Technical Service Bulletin: TSB110121

Common Cylinder Liners for C and ISC Series Engines

The purpose of this document is to introduce common cylinder liners for C and ISC Series engines.

Fig. 1, Old Liner/Old Block

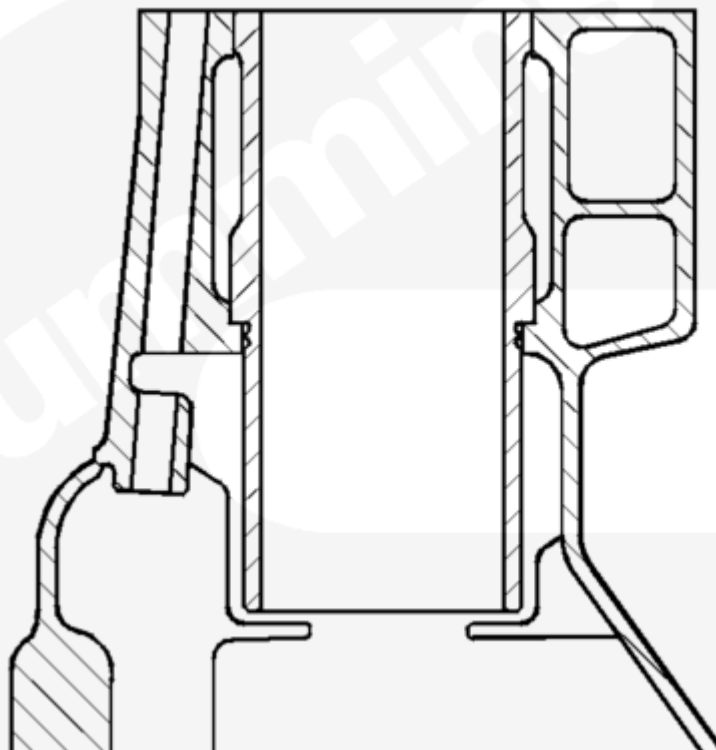
The ISC liner, Part No. 3944344, is 3-mm shorter than the C liner, Part No. 3919937. For this reason the old C block, Part No. 3928964, is designated for the shorter liner. To accept the shorter liner, block machining has been modified to stop 3-mm shorter than the old block (refer to Fig. 1 and 3). **When replacing C Series blocks, the liner must also be replaced.** Old liners in a new block will sit above the head deck by about 3 mm, which is unacceptable (refer to the Fig. 3). The ISC block, Part No. 3945063, will remain the same. Refer to the table below.
